Addendum-1

Hinds Parkway Gateway
Signage Landscaping

206007-002

Re: Addendum-1

1 SIGN ELEVATIONS

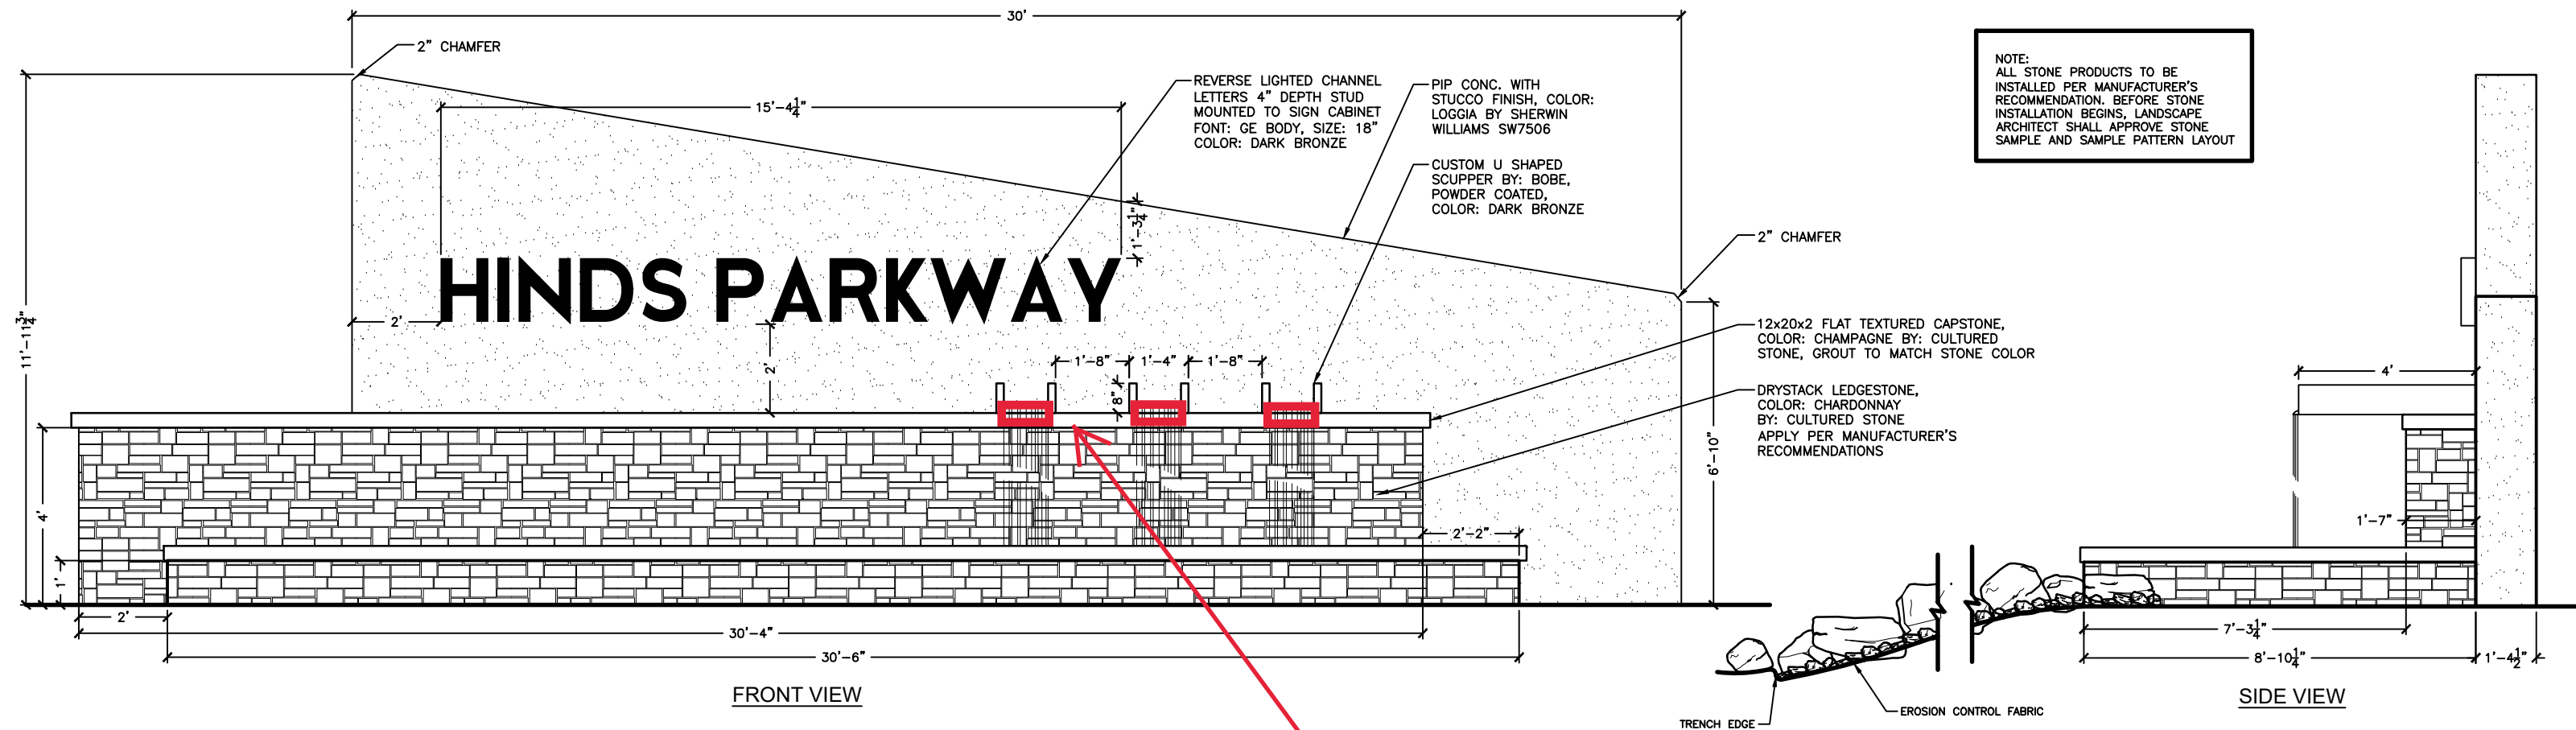
- 4) Junction box shown within the fountain basin is schematic in nature. Junction box to be located in the ground at the back of sign wall.
- 5) Lower wall precast caps to be broken by scuppers with the precast caps butting into scuppers. See attached sign elevation for clarification.

Move scuppers
down, precast cap
to butt scuppers
